SUBJECT: ISSUANCE OF AMENDMENT FOR THE WASHINGTON PUBLIC POWER SUPPLY SYSTEM
NUCLEAR PROJECT NO. 2 (TAC NOS. M87076 AND M88625)

The Commission has issued the enclosed Amendment No. 137 to Facility Operating License No. NPF-21 for WPPSS Nuclear Project No. 2. The amendment consists of changes to the Facility Operating License and Technical Specifications (TSs) in response to your application dated July 9, 1993, as supplemented by letters of October 8 and October 25, 1993, January 6, January 6, February 2, May 3, May 13, September 26, and October 12, 1994.

The amendment increases the authorized maximum power level of the reactor from the current limit of 3323 megawatts thermal (Mwt) to 3486 Mwt. The amendment also modifies TSs to incorporate the increased power limit in the plant operating limits. This request is in accordance with the generic power uprate program for boiling-water reactors (BWRs) established by the General Electric Company and approved by the NRC staff in a letter dated September 30, 1991.

CORE FLOW (% RATED)
Operating Region Limits of Specification 3.2.6
Figure 3.2.6-1

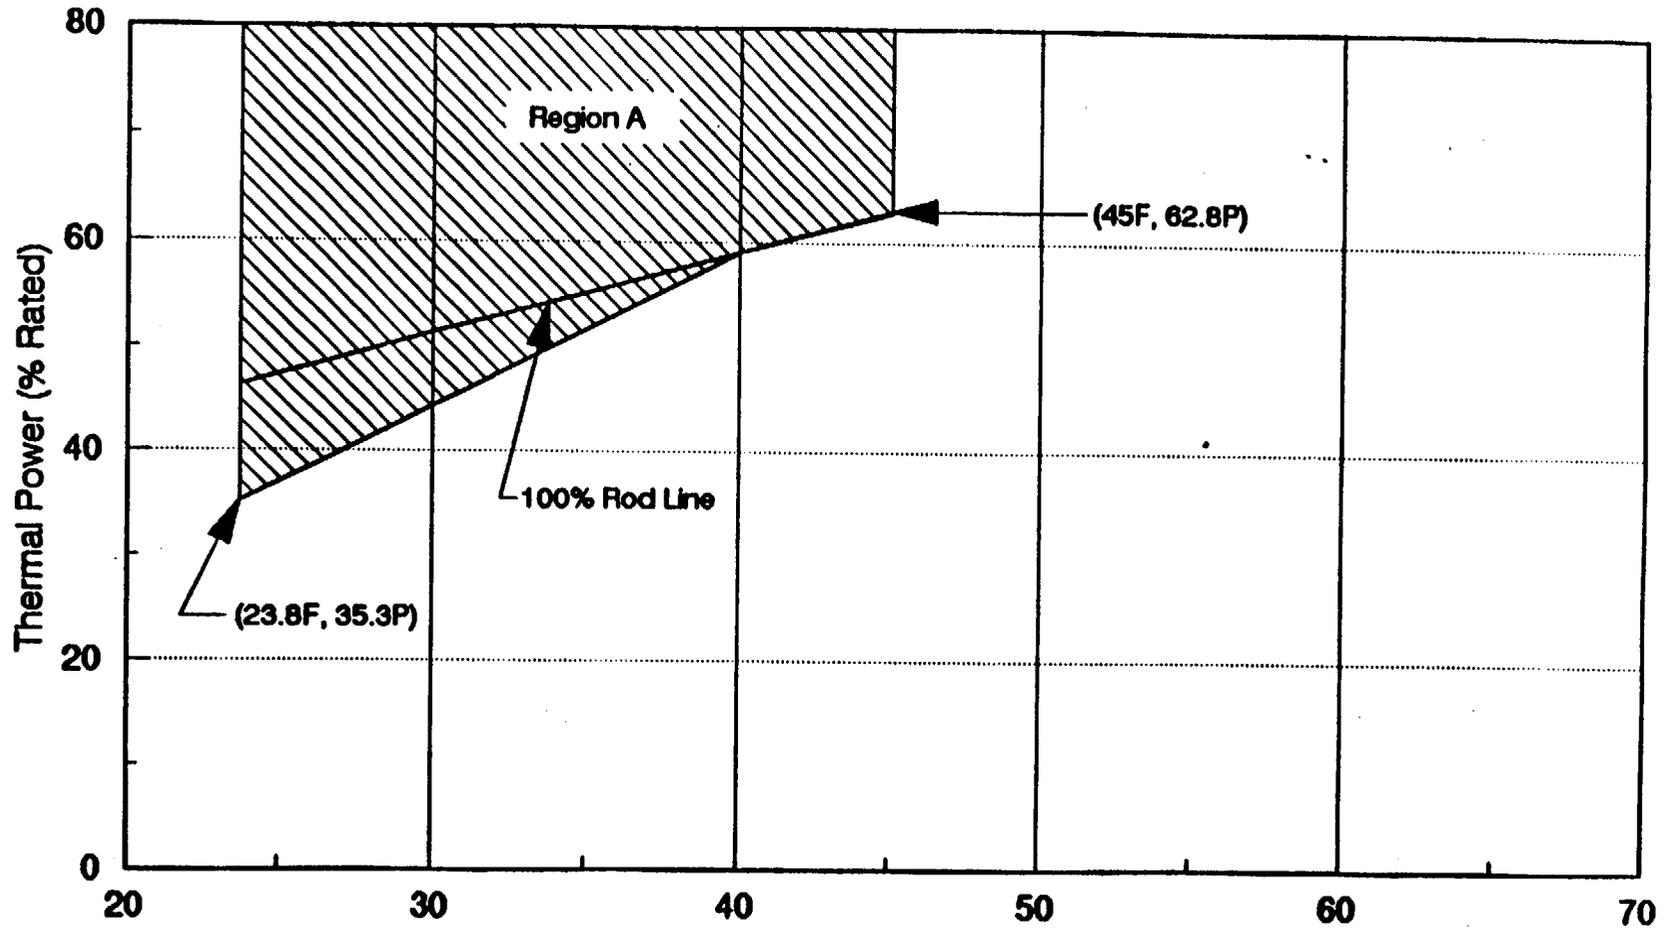
3.2.6 Operation with THERMAL POWER/core flow conditions which lay in Region A of Figure 3.2.6-1 is prohibited.

With THERMAL POWER/core flow conditions which lay in Region A of Figure 3.2.6-1, then as soon as practical, but in all cases within 15 minutes, initiate a MANUAL SCRAM.

4.2.6 The THERMAL POWER/core flow conditions shall be verified to lay outside Region A of Figure 3.2.6-1 once per 24 hours when operating in the region of APPLICABILITY.

CORE FLOW (% RATED)
Operating Region Limits of Specification 3.2.7
Figure 3.2.7-1

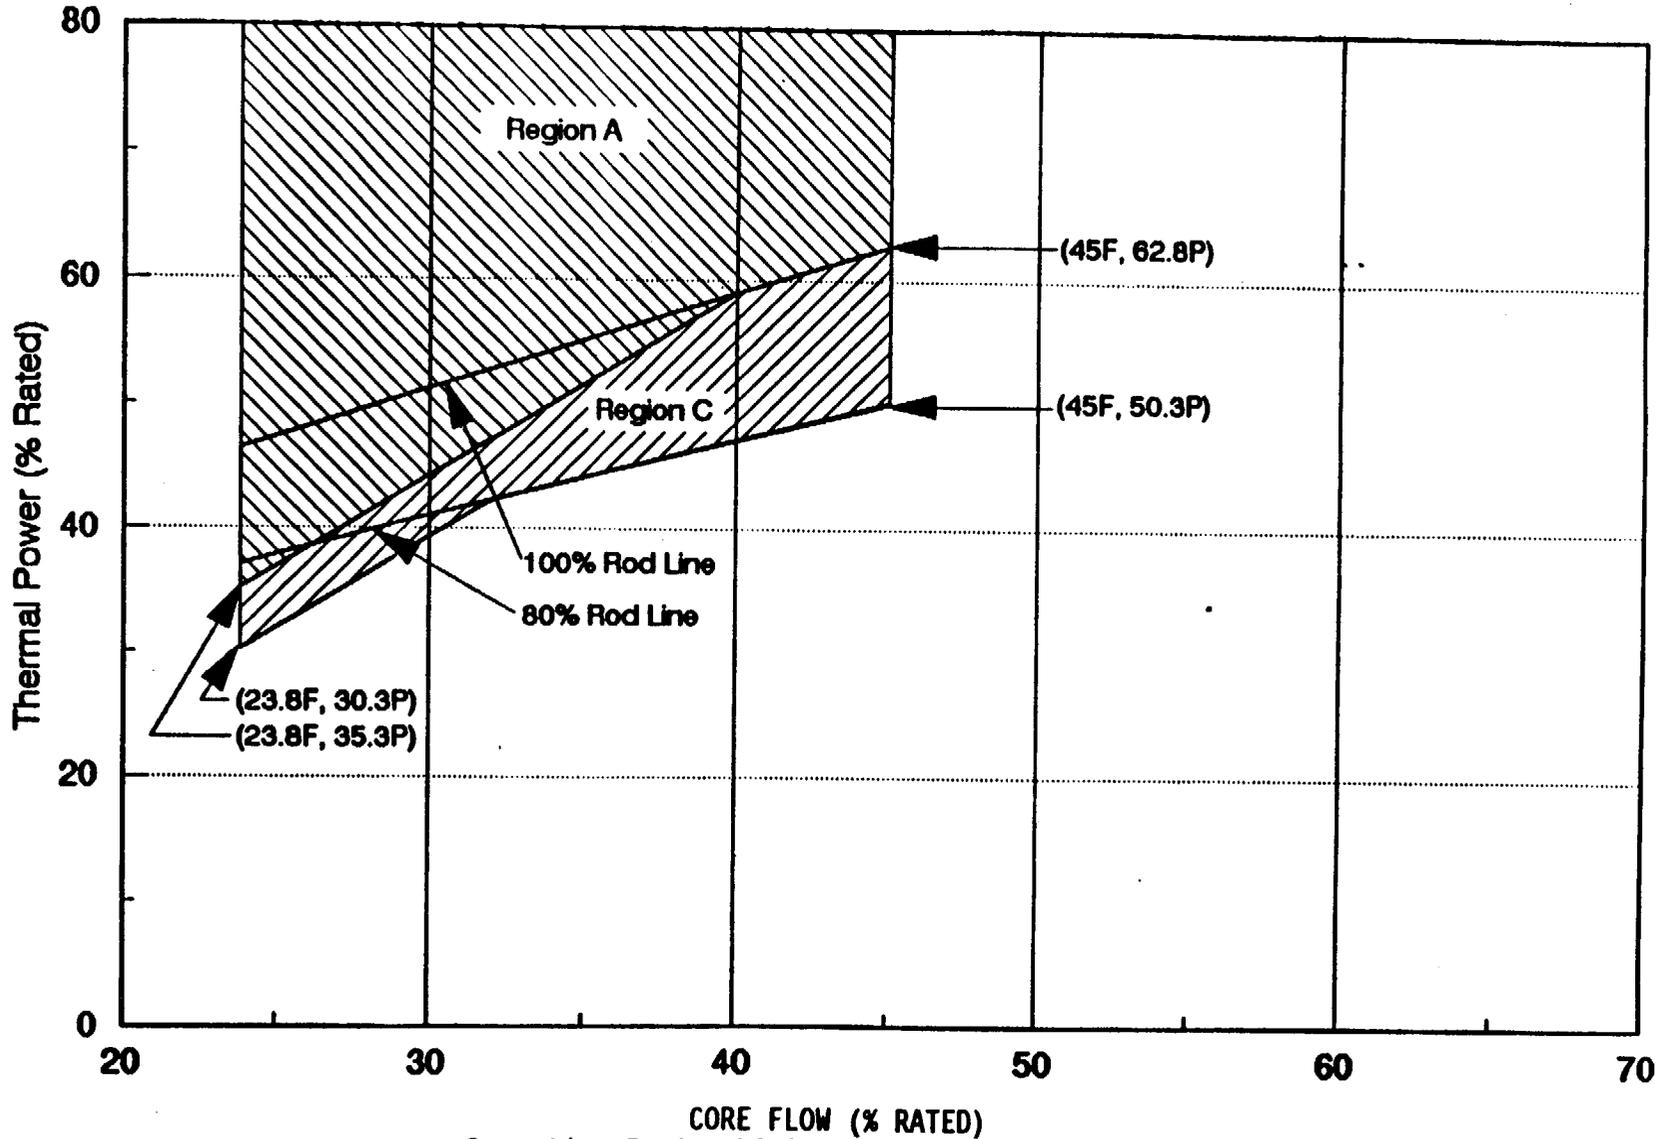
APPLICABILITY: OPERATIONAL CONDITION 1, with two recirculation loops in operation and THERMAL POWER/core flow conditions which lay in Region C of Figure 3.2.7-1.

As soon as practical, but in all cases within 15 minutes, initiate action to exit the region of APPLICABILITY by either decreasing THERMAL POWER with control rod insertion or increasing core flow with recirculation flow control valve manipulation. The starting or shifting of a recirculation pump for the purpose of exiting the region of APPLICABILITY when the stability monitoring system is inoperable is specifically prohibited. Exit the region of APPLICABILITY within one (1) hour.

Core Flow (% RATED)
Operating Region Limits of Specification 3.2.8
Figure 3.2.8-1

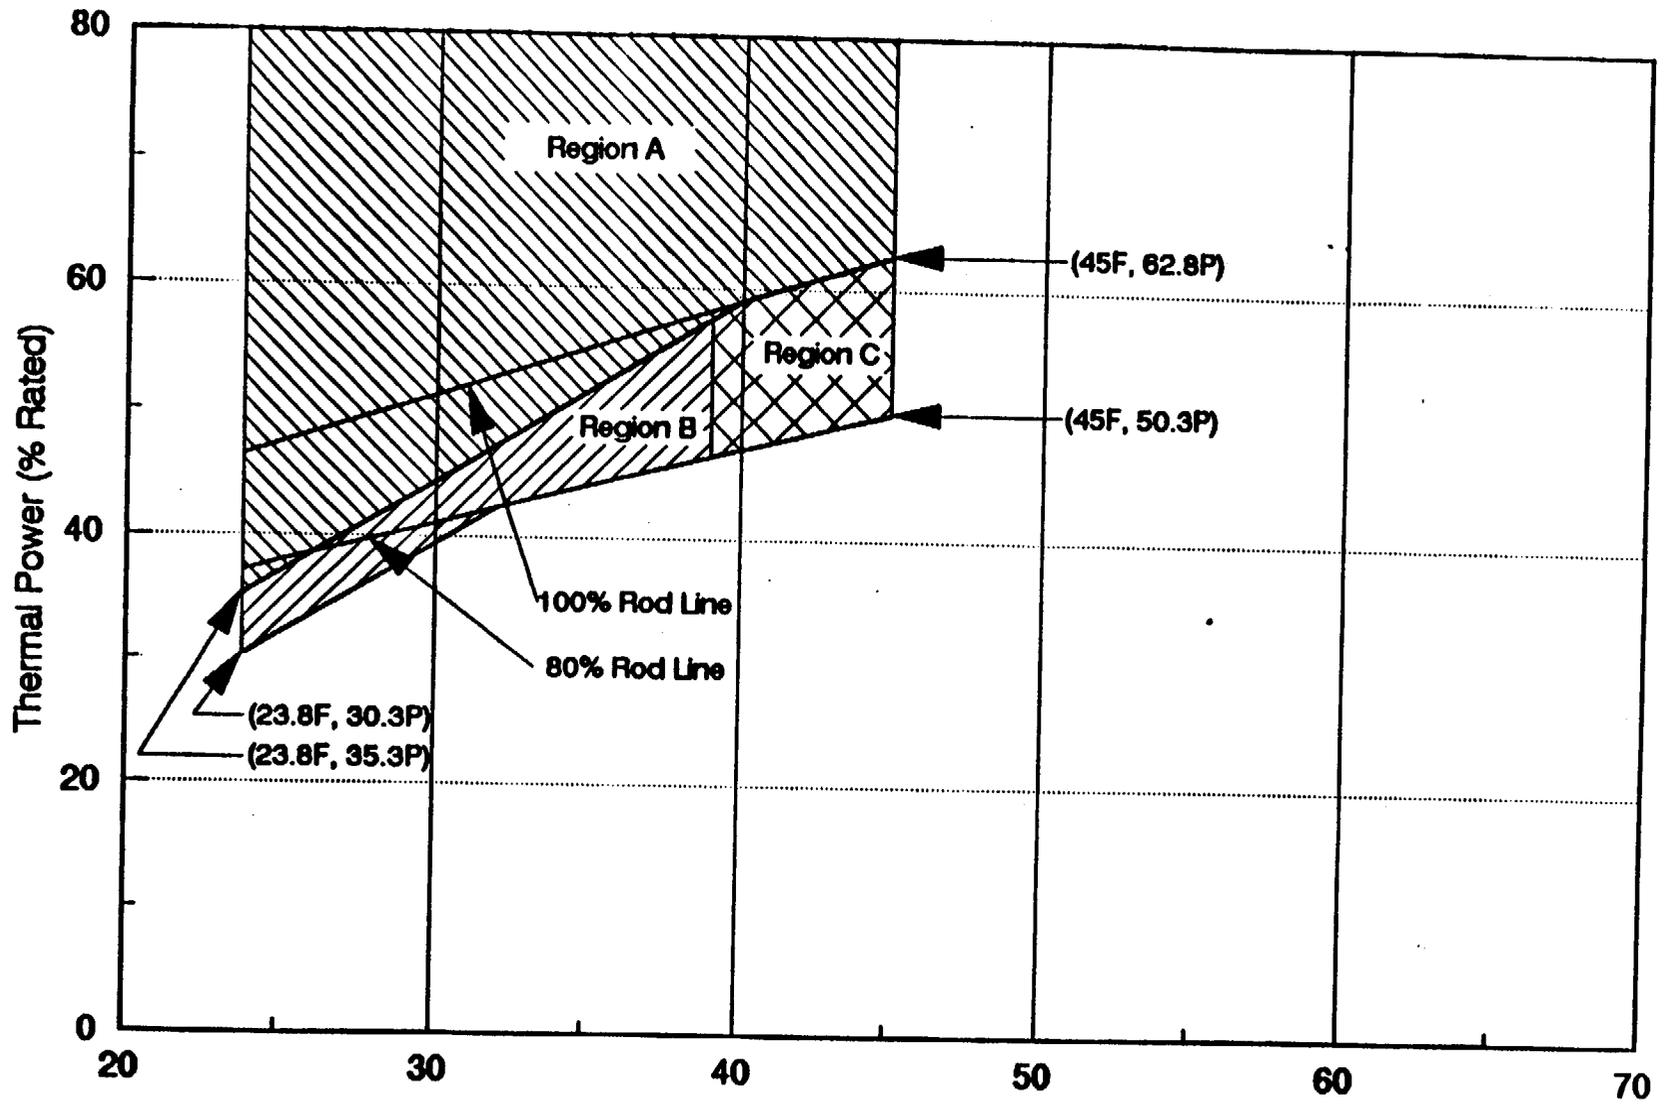
APPLICABILITY: OPERATIONAL CONDITION 1, with one recirculation loop in operation and THERMAL POWER/core flow conditions which lay in Region C of Figure 3.2.8-1.

As soon as practical, but in all cases within 15 minutes, initiate action to exit the region of APPLICABILITY by decreasing THERMAL POWER with control rod insertion. Exit the region of APPLICABILITY within one (1) hour.

Core Flow (%Rated)
OPERATING REGION LIMITS OF SPECIFICATION 3.4.1.1
FIGURE 3.4.1.1-1

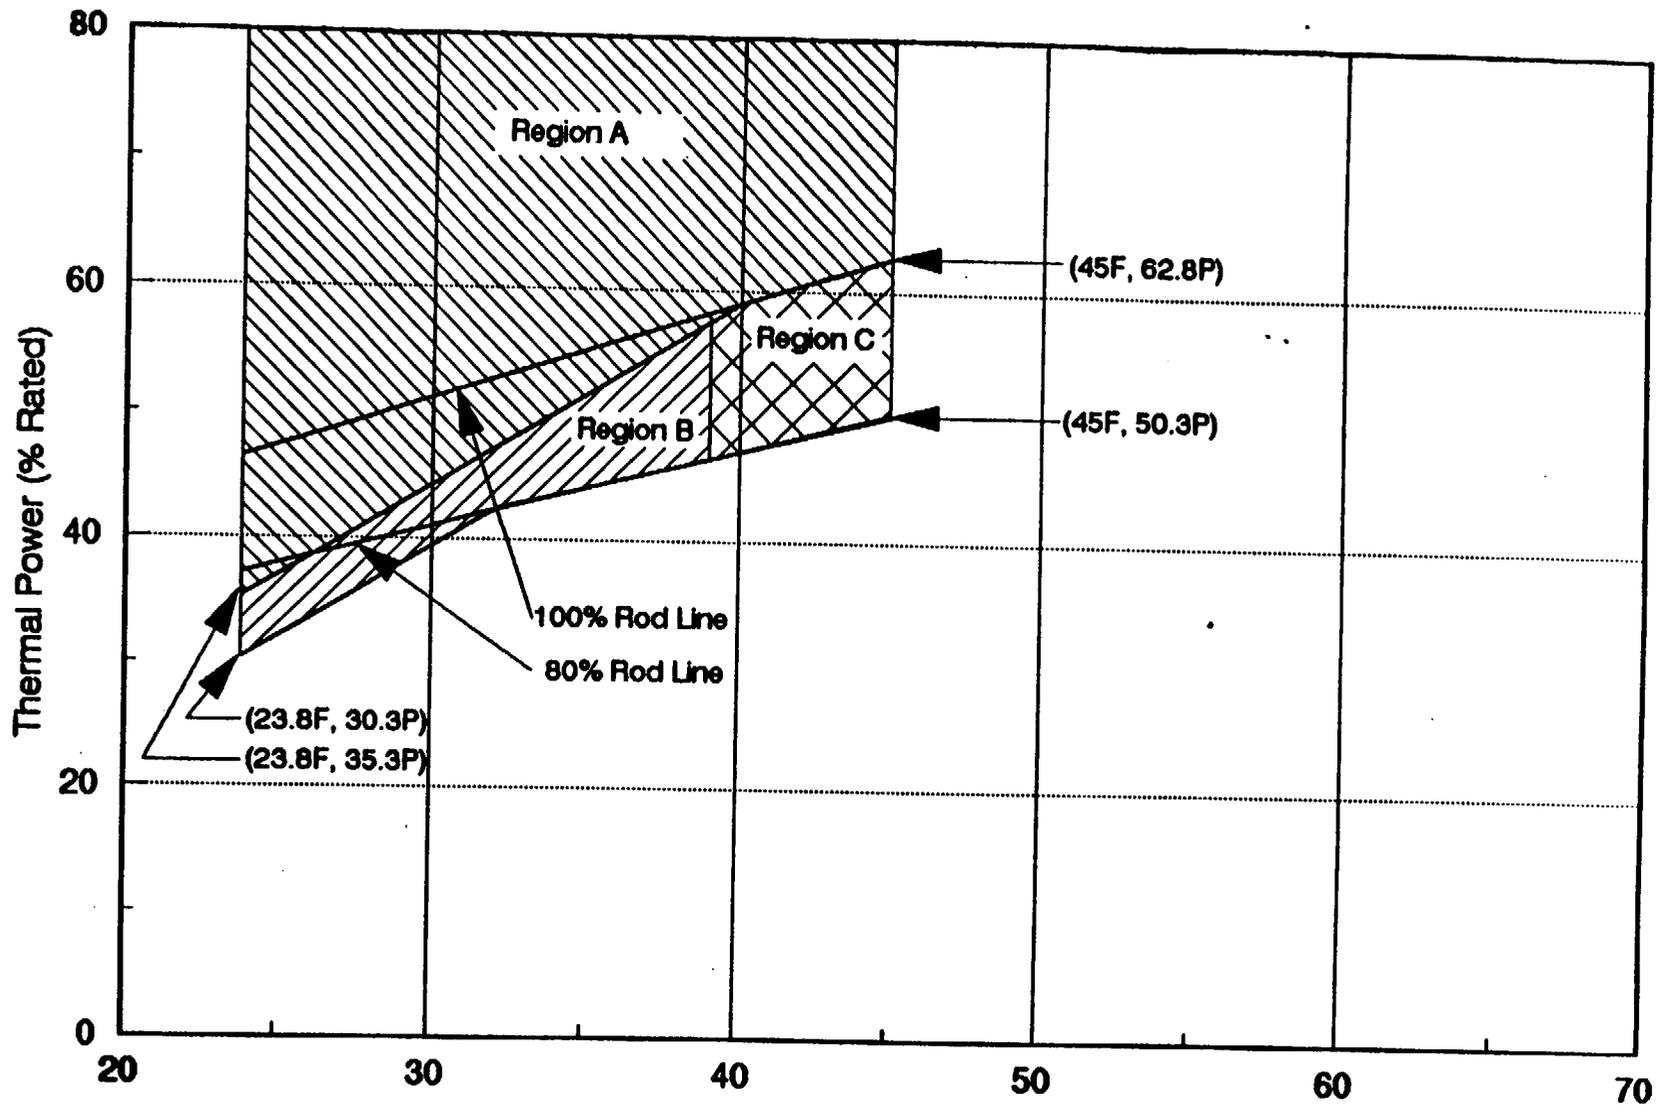
- c. Core flow is greater than or equal to 39% of rated core flow when core THERMAL POWER is greater than the limit specified in Figure 3.4.1.1-1.

FIGURE 3.4.6.1A

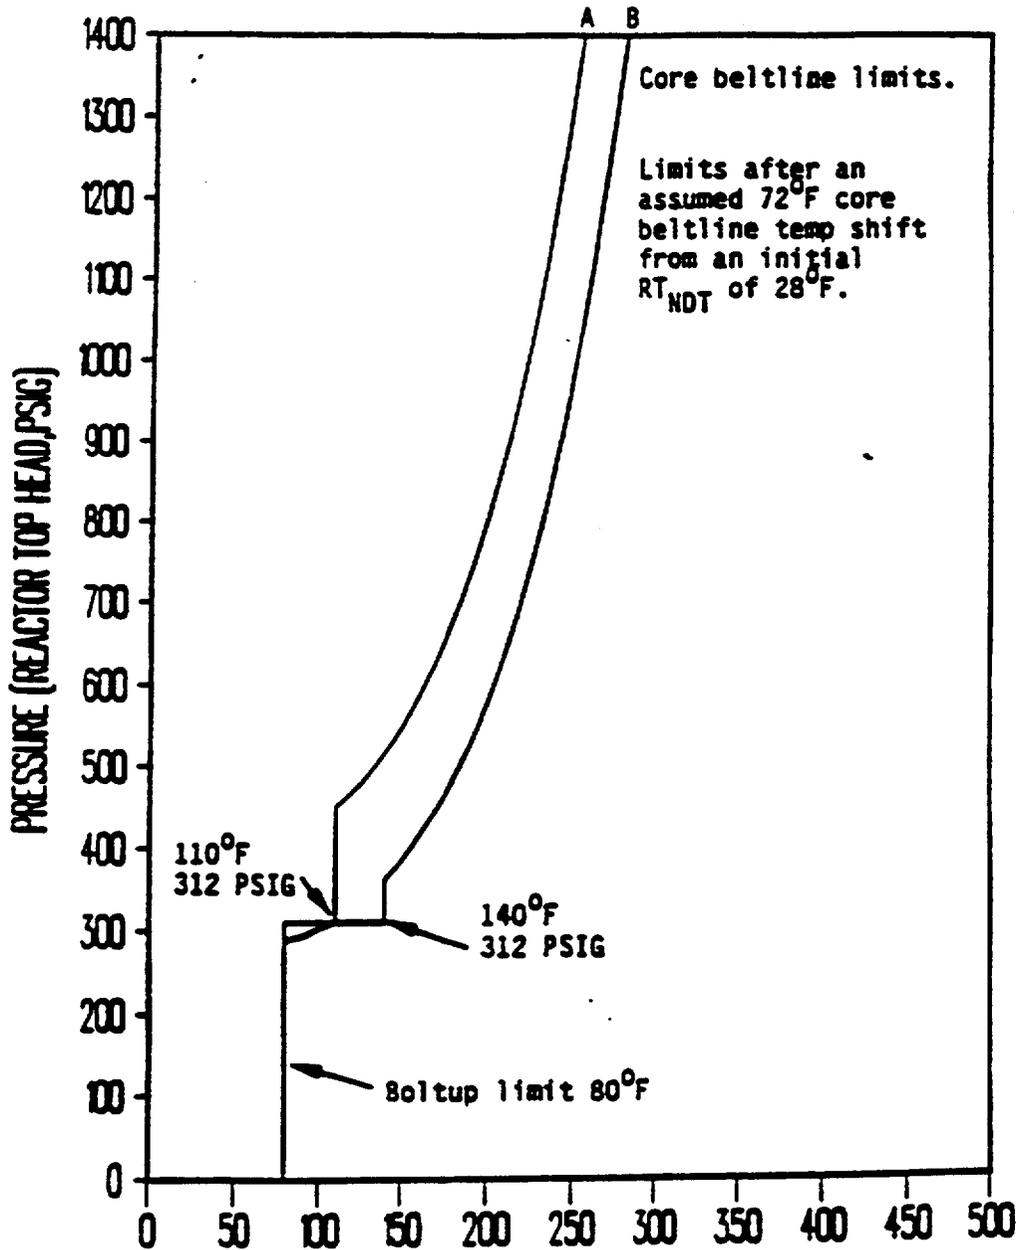
4.4.6.1.3 The reactor vessel material surveillance specimens shall be removed and examined, to determine changes in reactor pressure vessel material properties as required by 10 CFR Part 50, Appendix H in accordance with the NRC approved schedule. The results of these examinations shall be used to update the curves of Figures 3.4.6.1A and Figure 3.4.6.1B.

FIGURE 3.4.6.1.c

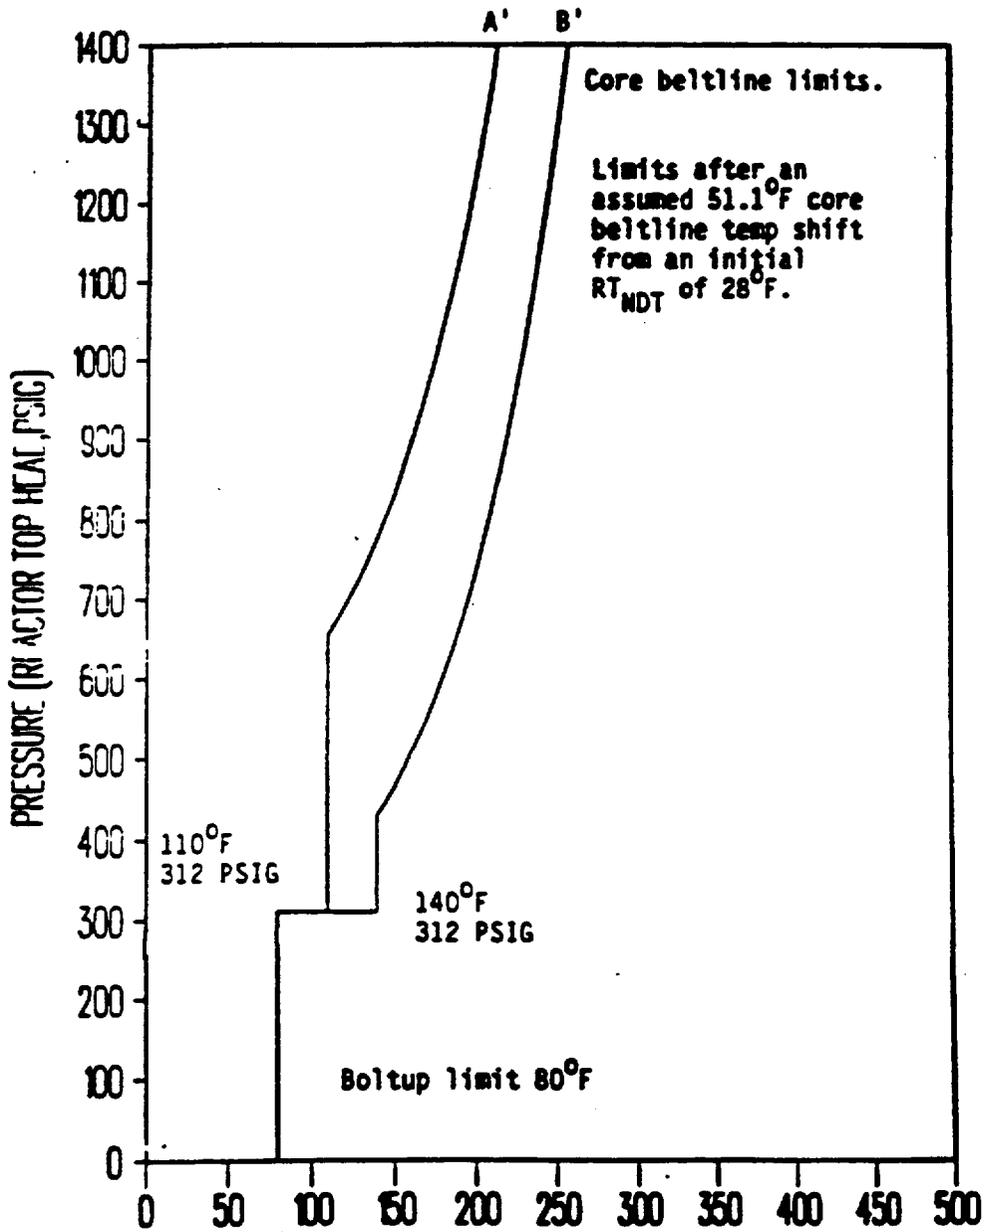
*Figure 3.4.6.1.c A' and B' curves are effective for less than or equal to 8 EFPY of operation.
